**Proposed Rezoning From “AGR” & “GB” To “G/IC” for
a Proposed “Social Welfare Facilities” (Residential Care Homes for The Elderly) (RCHE)
Lot 232 RP, 232 S.A RP, 232 S.A ss. 1 to 14, 232 S.B RP, 232 S.B ss. 1 to 27,
232 S.C to 232 S.E, 233 RP, 233 S.A to 233 S.M, 237 RP, 237 S.A to 237 S.R,
239 RP, 239 S.A to 239 S.G in D.D.23, Tung Tsz, Tai Po, N.T.
S12A Application for Planning Application No. Y/NE-TK/19
Response-to-Comment – SWD
(Updated 21 February 2025)**

G-04

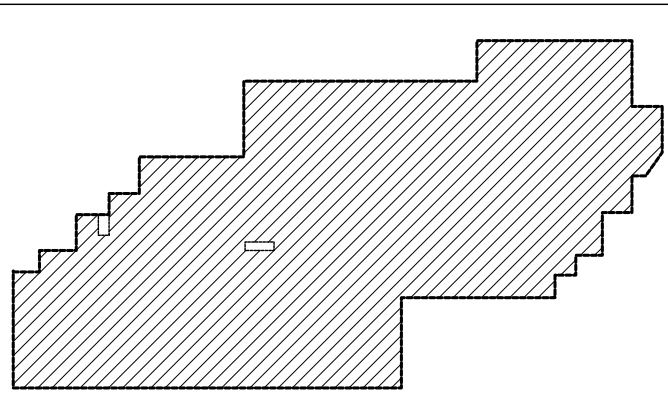
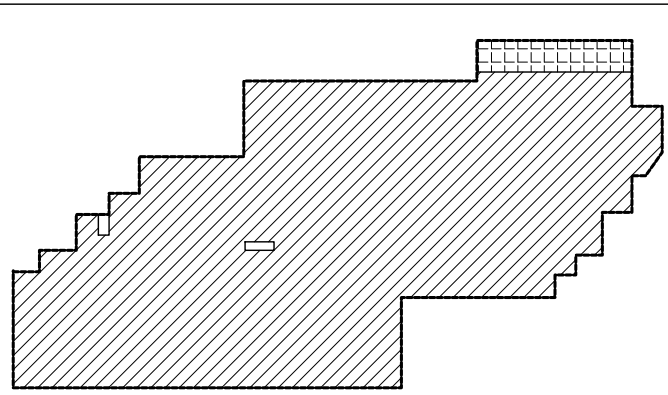
Comments	Response
ambulances.	vehicles.
14. The basic facilities in the RCHE shall include dining/sitting area. Please indicate on the layout plan if this is provided.	Revised. Please refer to G-04 to G-06.

18. Please provide a more detailed layout of the attached toilets cum bathrooms/shower rooms inside the dormitories and suites.	Revised. Please refer to G-04 to G-06.
Whether Premium Concession Scheme is applicable to the proposed RCHE	
<ul style="list-style-type: none"> The proposed RCHE should comply with all the requirements of the Incentive Scheme to Encourage Provision of Residential Care Home for the Elderly Premises in New Private Developments (the Incentive Scheme) as set out in Lands Department (LandsD)'s Practice Note Issue No. 5/2023. 	Noted.

G-05 1:200 (A3)

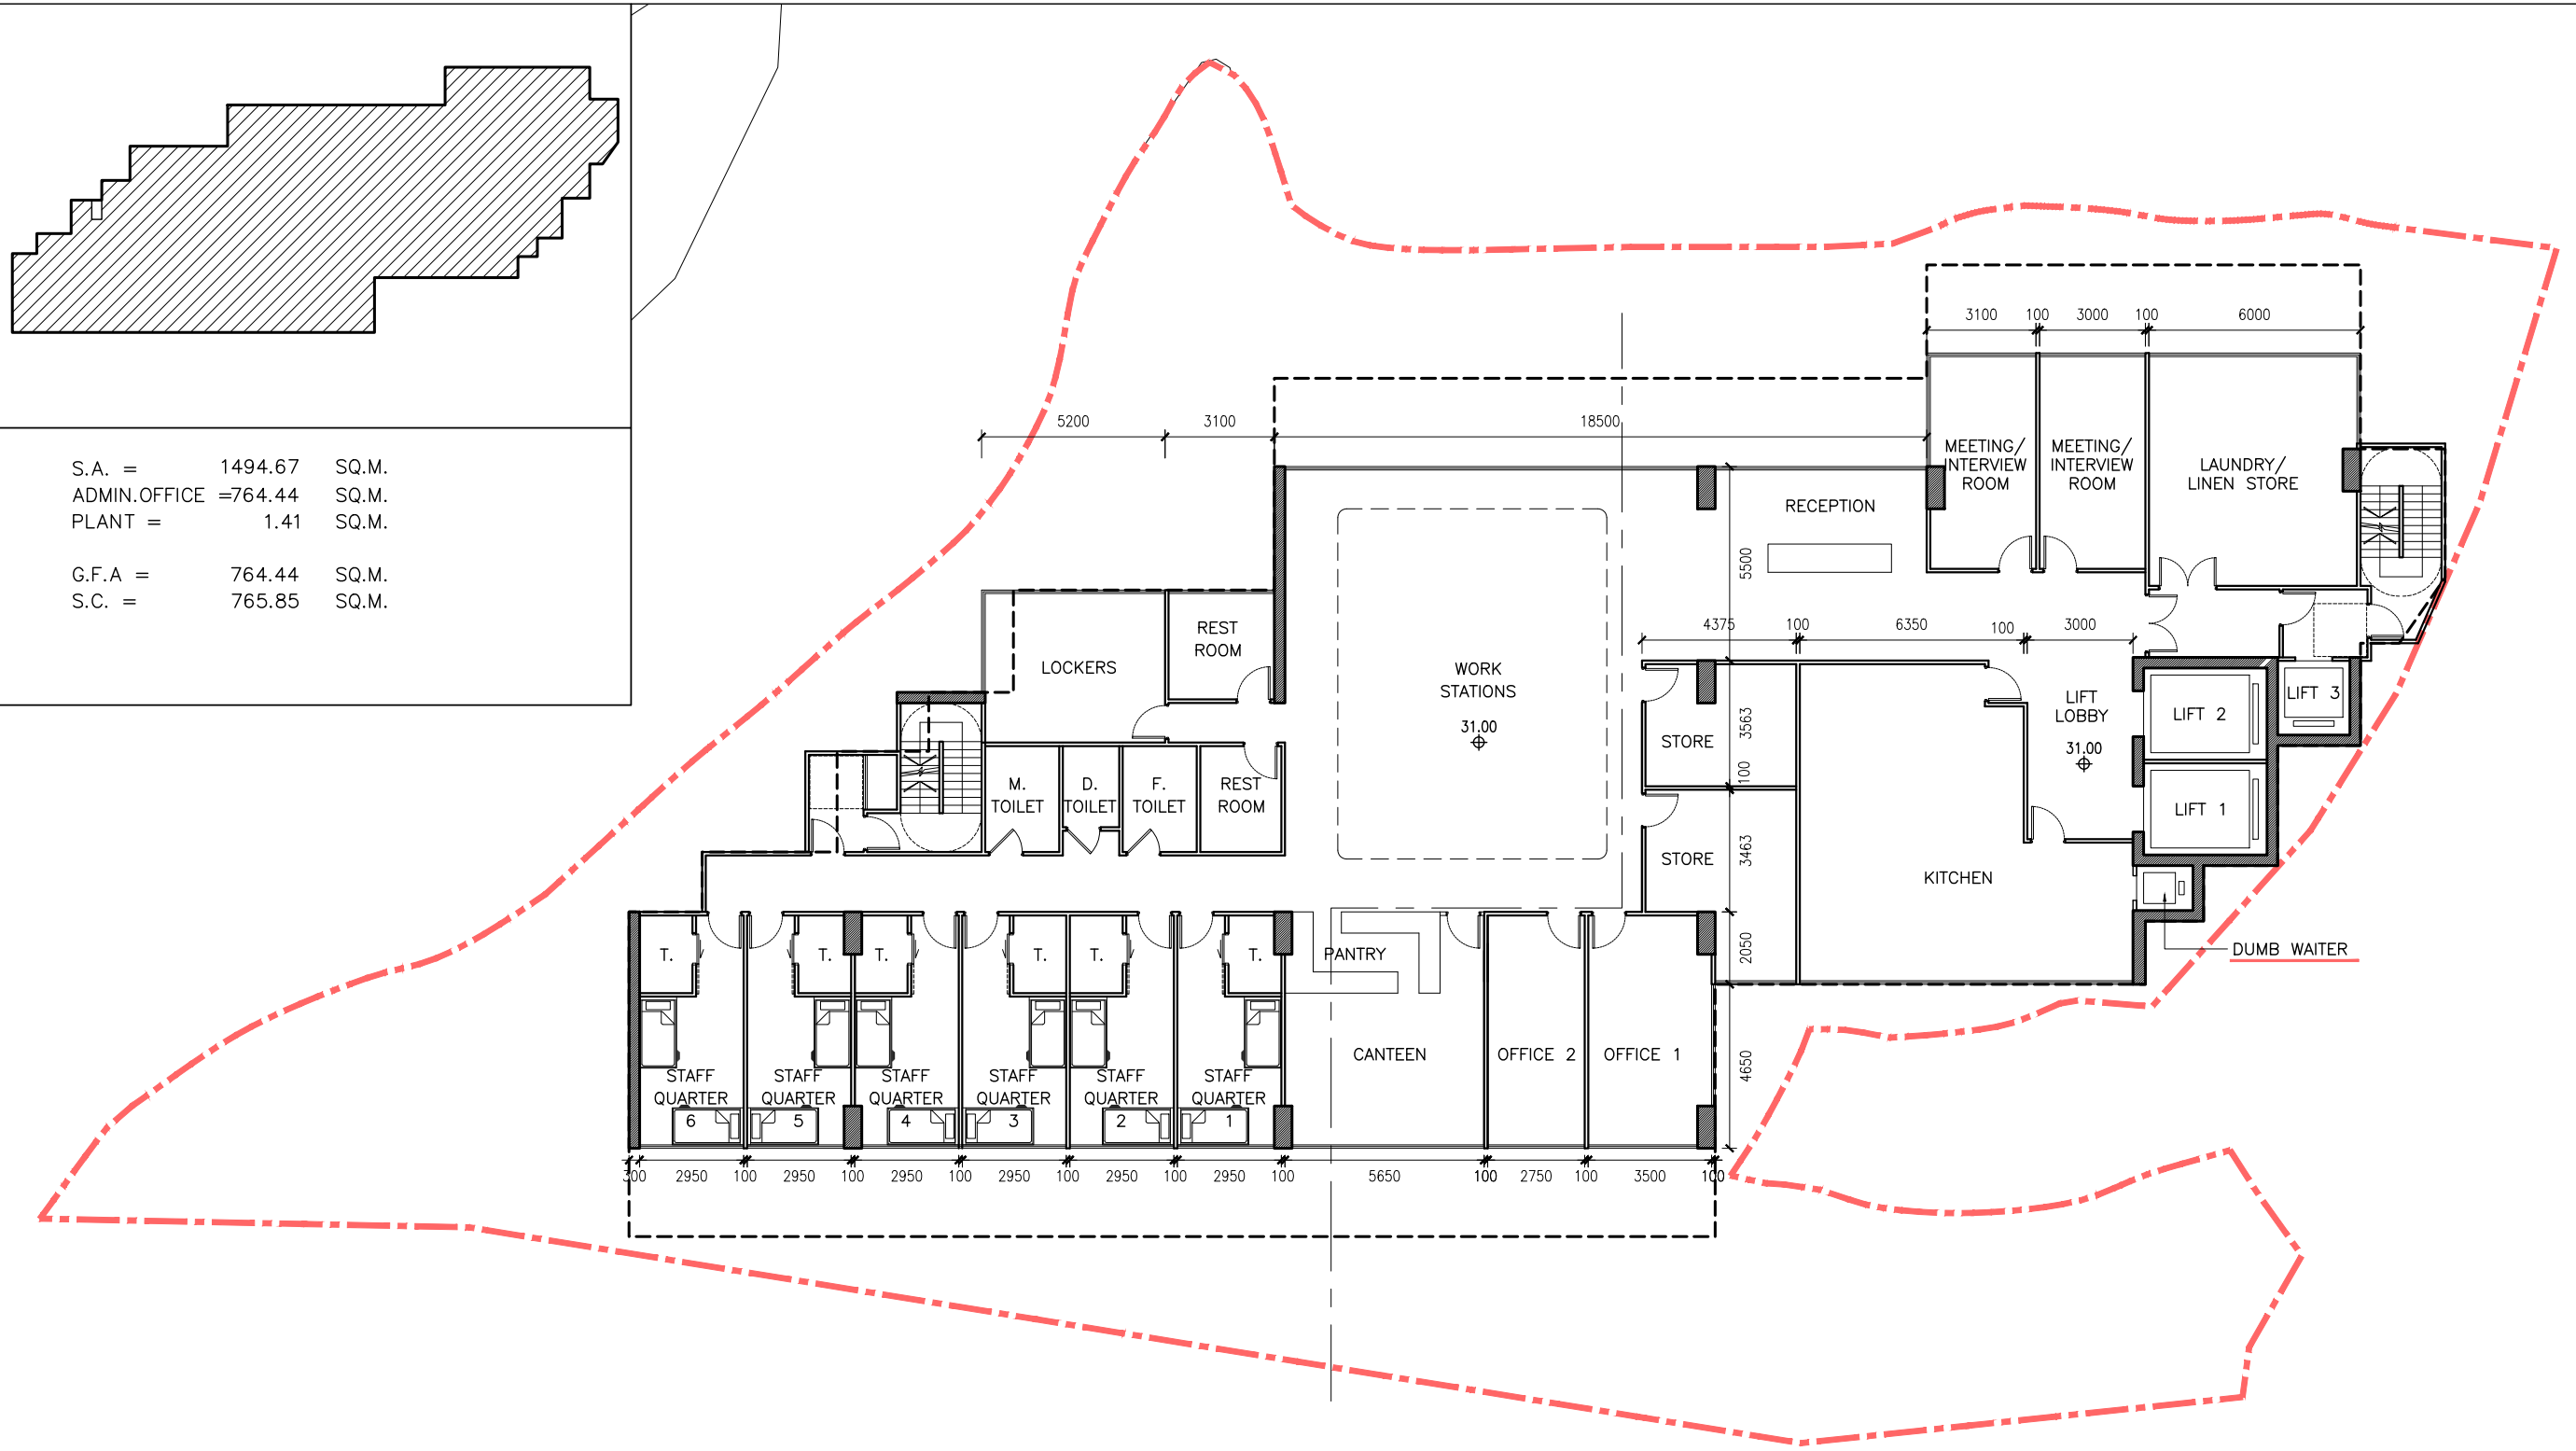
<p>5. Barrier free access for the disabled has to be provided in the RCHE premises.</p>	<p>Complied.</p>
<p>6. The applicant should ensure that the RCHE shall be accessible by emergency services.</p>	<p>The RCHE is accessible by emergency services like Ambulance.</p>
<p>7. It is noted that two beds inside the 2-bed suites are placed adjacent to each other without any passage between the beds. According to Section 21(a) of Residential Care Homes (Elderly Persons) Regulations, Cap. 459A, every passage and doorway shall be wide enough to accommodate residents using walking aids or wheelchairs.</p>	<p>Revised. Refer to G-05, G-06.</p>
